## United States Patent and Trademark Office

APPLICATION NO.	FILING DATE	FIRST NAMED INVENTOR	ATTORNEY DOCKET NO.	CONFIRMATION NO.
10/772,965	02/04/2004	Kazuhiko Gogo	14470.22US01	5309
7590 05/01/2006 HAMRE,SCHUMANN,MULLER & LARSON, P.C			EXAMINER	
			SY, MARIANO ONG	
P.O. BOX 2902-0902 MINNEAPOLIS, MN 55402		ART UNIT	PAPER NUMBER	
MINNEAFOLI	15, IVIN 33402		3683	
			DATE MAILED: 05/01/2006

## **DETAILED ACTION**

See the reproduced Fig. 3 of Rath '510 below.

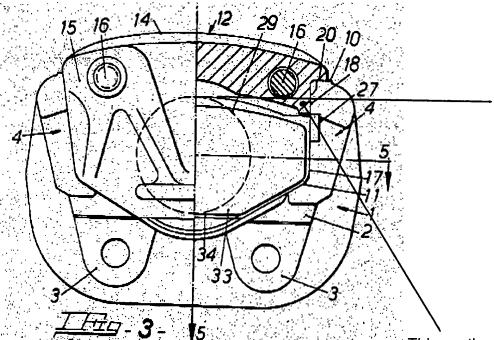
Applicant argued in the Remarks that Rath (US 3,782,510) does not disclose a disk brake unit for a motorcycle, where part of the bridge section projects further radially

inwards than an outer peripheral edge of the piston. As evident from reproduced Fig. 3 of Rath the area labeled by Applicant as "GAP" in Fig. 3, no portion of the part 14 projects radially inward beyond the outer edge of the outline of the bore 29. Since the piston slides in the bore 29, no portion of the part 14 projects radially inward beyond the outer peripheral edge of the piston.

Examiner disagrees with Applicant's argument and maintains the claim language is broad and Rath '510 still reads on the claim language.

This section of the caliper body can be read as part of the bridge section projecting further radially inwards than the outer peripheral edge of the piston Application/Control Number: 10/772,965 Page 5
